**Questions for CanWhite Virtual Open House for the Vivian Sand Extraction Project
and Hydrogeological Report
by D.M. LeNeveu B.Sc. (hons. physics) M.Sc. (biophysics) B.Ed.
Aug. 20, 2021**

Figure 1. Limestone thickness in the carbonate aquifer of the CWS BRU extraction area.

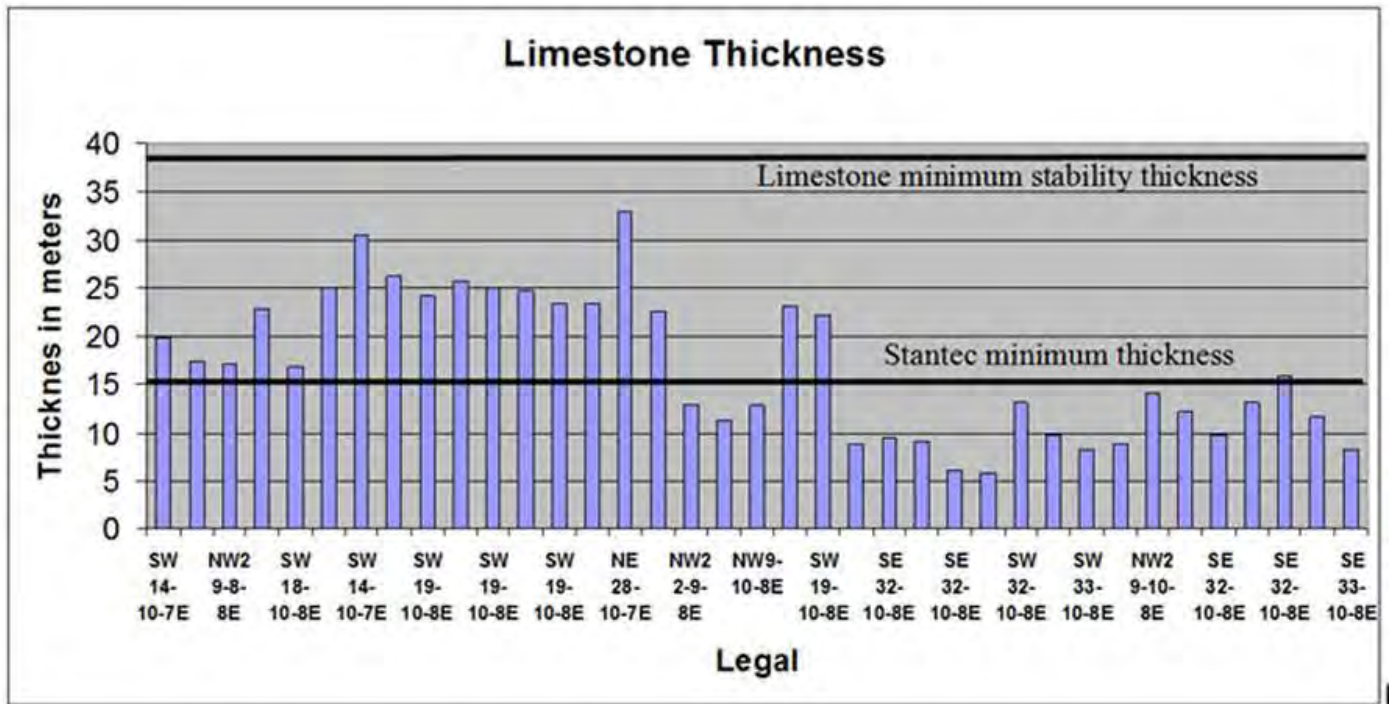
A peer reviewed paper by Waltham and P. Fookes specifies that minimum stability thickness for limestone above a cavity must be 70% of the cavity opening dimension excluding overburden cover.¹ For the CWS standard design opening for a seven well extraction cluster the limestone thickness must be at least 37.8 m. The limestone of the carbonate aquifer in the Bru extraction area has a thick overburden cover of glacial till whose unsupported weight will increase the minimum stability thickness for the limestone.

Figure 1 shows the limestone thickness of the carbonate aquifer in the Bru extraction area and the Stantec and Waltham and Fookes thickness limits. The data was taken from CWS well records supplied by Manitoba Groundwater and from the CWS borehole records in the hydrogeological report. The well records demonstrate that over the entire Bru extraction area all limestone thicknesses are less than the minimum criteria stated by Waltham and Fookes for stability. All limestone thicknesses in the eastern Bru area where extraction activities will begin are less than the Stantec limit of 15 meters. The limestone thickness in general increases westward.¹³

Will CWS move their operations westward into the ALY area where the limestone is thicker and the sandstone aquifer is saline to avoid subsidence?

Figure 2. Cover collapse sinkholes from USGS.³

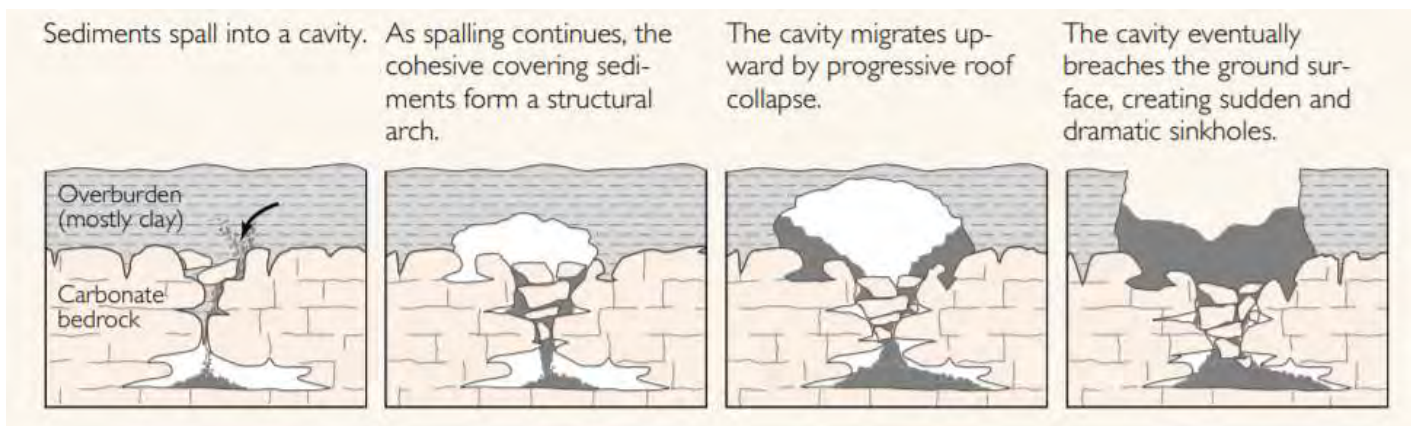
The glacial till overburden will gradually migrate into the cavity through the compromised limestone layer causing a cover collapse condition. In cover collapse subsidence the cavity created in the till overburden by gradual migration through the limestone layer will suddenly collapse at some undetermined time in the future leaving a large sinkhole as illustrated in Figures 2 and 3. All of the well clusters created by CWS operations are susceptible to cover collapse. A moonscape of water filled sinkholes will be eventually created. Water contaminated iron bacteria, fecal coliform from septic fields and animal feces, other microbes, and chemicals from surface runoff will have direct access to the carbonate aquifer and the sandstone through the compromised shale aquitard. This subsidence scenario is untenable.

Figure 3. Sinkhole development from CWS sand extraction²

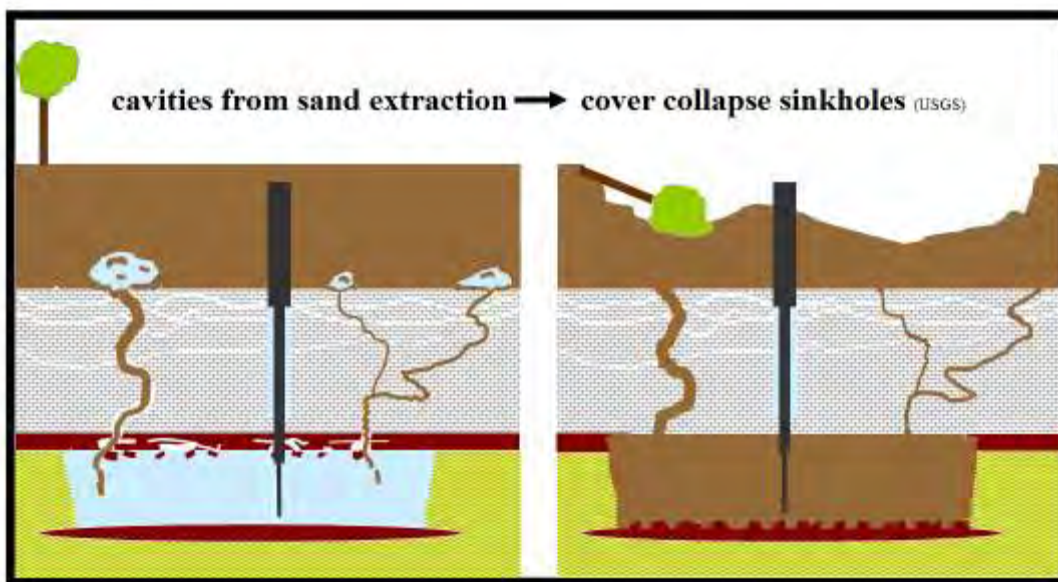
A report released by What the Frack Manitoba in February 2021, peer reviewed by A. Ingraffea of Cornell University a world renowned expert on geo-mechanics, determines the shale aquitard will be unstable and slake into the cavity from the sand extraction.²

Figure 4. CWS 24 year project area overlaid on the map of the extent of the Carman sands (green speckled area) south of Vivian MB.

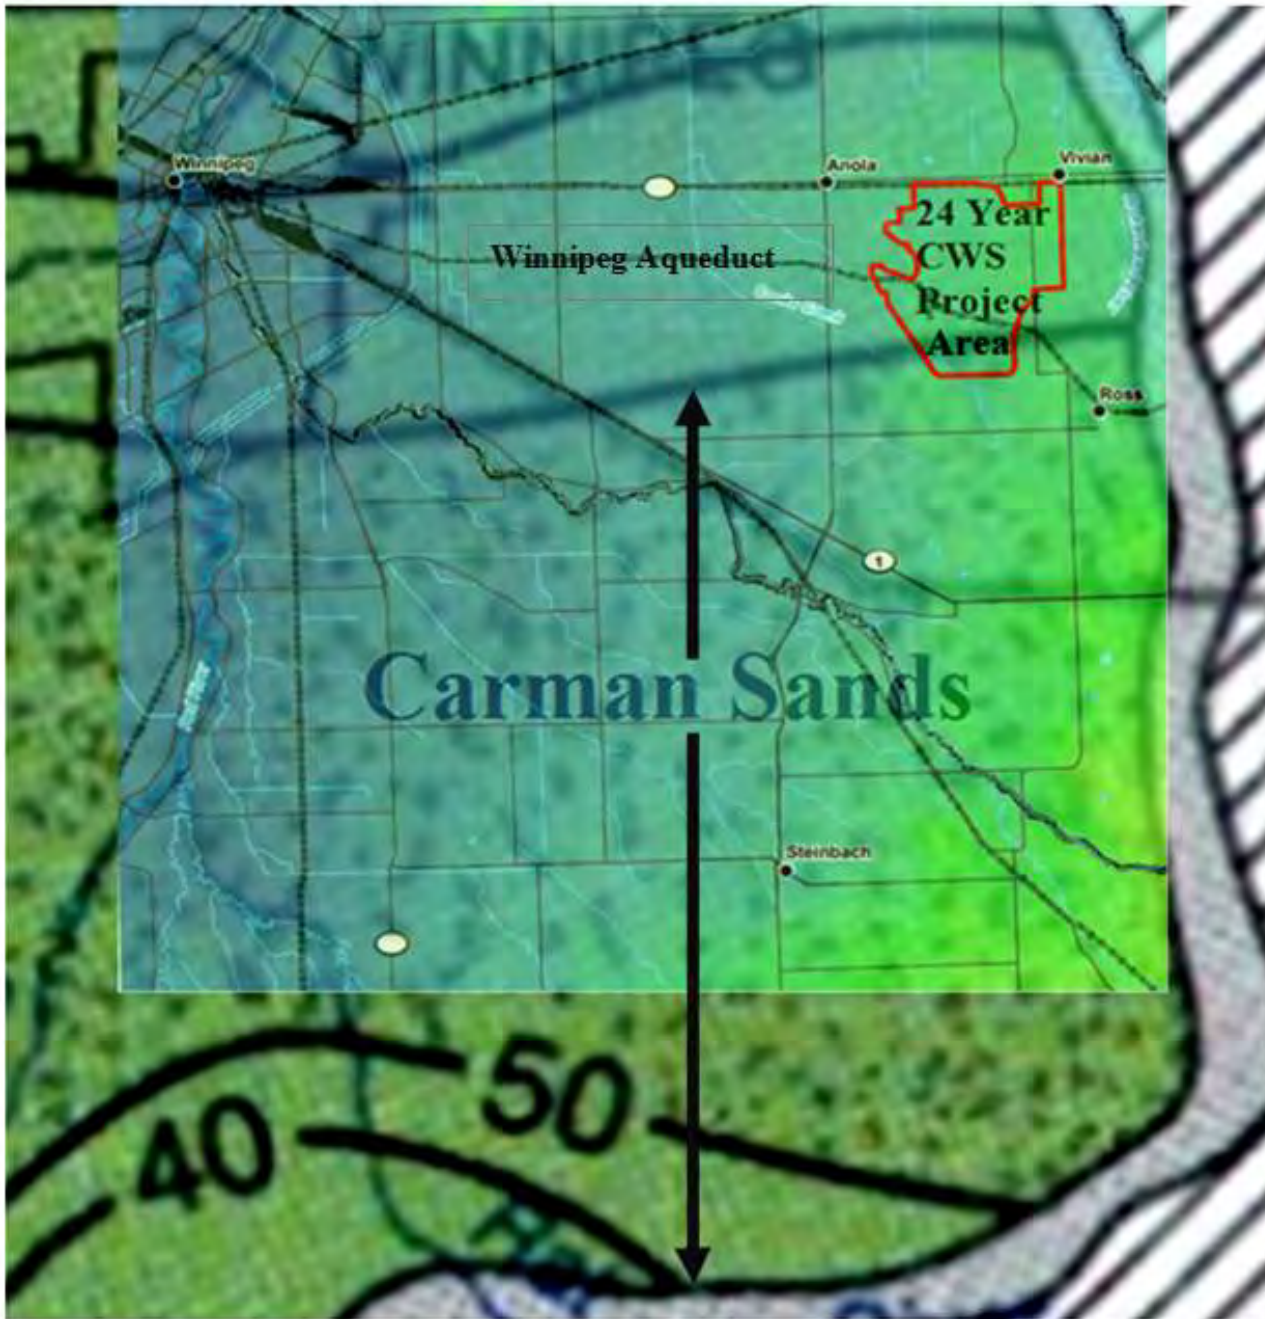
The above quote states the Carman Sands are below the Sandilands area. Figure 4 shows the Carman Sands as determined from the Manitoba Energy and Mines Bedrock Geology Compilation Map Series ¹³ overlaid on the CWS 24 year Project area. Figure 4 clearly shows only very southern portion of the project area is within the Carman sands.

Thus even the lower portion of the Carman Sands in the southern portion of the claim area is interbedded with shale that is likely rich in pyrite.

Does CWS acknowledge the northern part of the BRU project area is wholly within the Black Island member part of the Winnipeg formation known to contain pyritic shale, marcasite coating the sand, pyritic concretions such as oolite layers and not within the Carman sands area?^{10,12,14,15} Does CWS acknowledge that the Black Island member from which sand will be extracted in the northern portion of the Bru area contains pyrite that will be exposed to re-injected aerated water that will form acid and mobilize heavy metals and selenium thereby contaminating the aquifer?

As illustrated in figure 4 the Winnipeg aqueduct traverses the entire 24 year CWS project area. The slurry lines will eventually have to cross the aqueduct likely multiple times. The aqueduct is known to have cracks that allow infiltration of surface water.²⁵ Slurry line spills near the aqueduct could contaminate Winnipeg’s drinking water supply with arsenic, selenium, other heavy metals and the highly toxic acrylamide monomer.²⁴
